Ref: SSD-79276958
Council Ref: S14890

RE: SUBMISSION TO SSD-79276958 FOR RESIDENTIAL FLAT BUILDING WITH INFILL AFFORDABLE HOUSING

Attachment 1 - Ku-ring-gai Council's Response to Applicant's RtS

Figure 1 - Zoning under SEPP Station Precincts (Source: NSW Planning Portal Spatial Viewer)

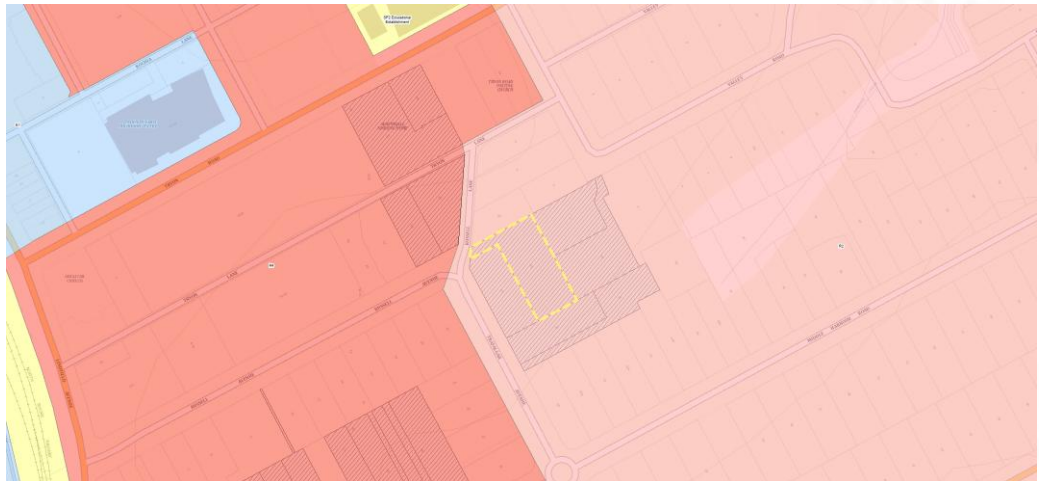
Under the SEPP Station Precincts, the subject sites are all zoned R2 Low Density Residential (refer to **Figure 1**).

Therefore, as gazetted within the SEPP Station Precincts, the desired future character is established for the subject sites. Through the amending legislation, it is ultimately desired that the existing low density residential character of the area (eastern side of Trafalgar Avenue, northern side of Middle Harbour Road and southern side of Valley Road) be retained. The proposal is reliant on the "saved" provisions of the former Transport Orientated Development (TOD) SEPP of the subject sites rather than acknowledging the current and desired future character of the area as maintained under SEPP Station Precincts. Specifically, the low-density and low-scale character of the neighbourhood to the eastern side of Trafalgar Avenue.

Figure 3 - hatched area (red) annotates areas included in the landscape area calculation.

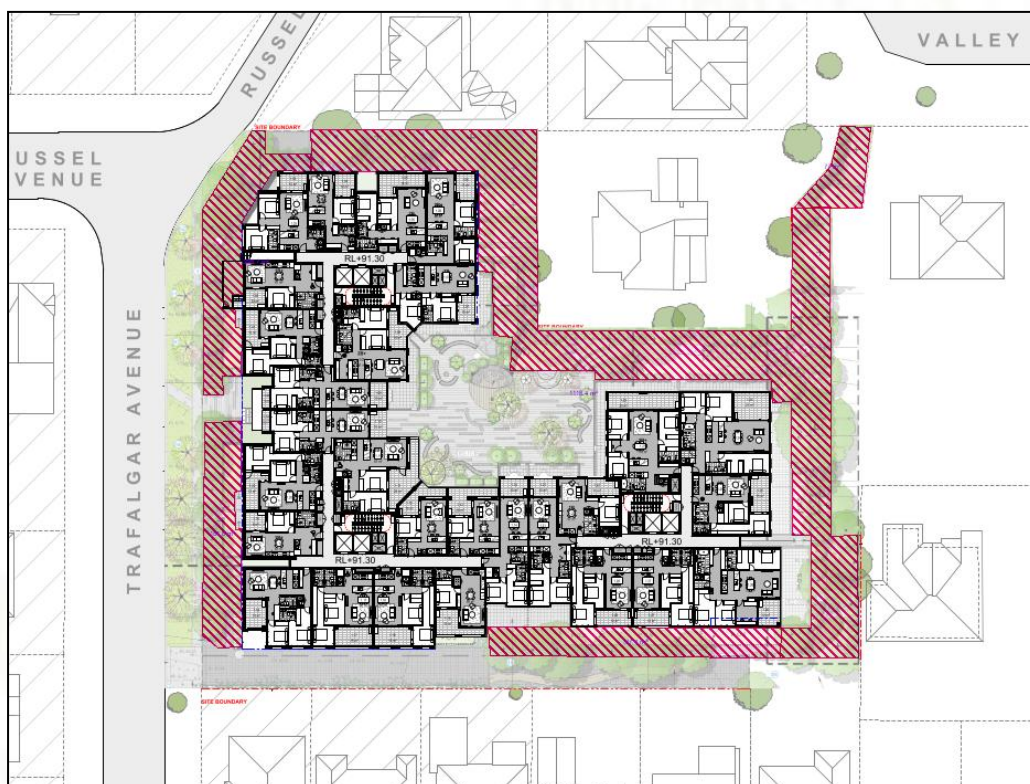
The proposal does not meet clause 2 (b) (ii) of Chapter 2 [SEPP (Housing) 2021]: 2 (b) a minimum landscaped area that is the lesser of— (i) 35m² per dwelling, or (ii) 30% of the site area.

The proposal states the landscaped area provided is 3,124sqm, being 46.8% of the site area.

Based on this assessment, Council's Senior Landscape Assessment Officer calculates that the proposal provides a landscape area of 1,793sqm, representing 26.8% of the site area as opposed to the 30% requirement for In-fill Affordable Housing (Refer to **Figure 3** below).
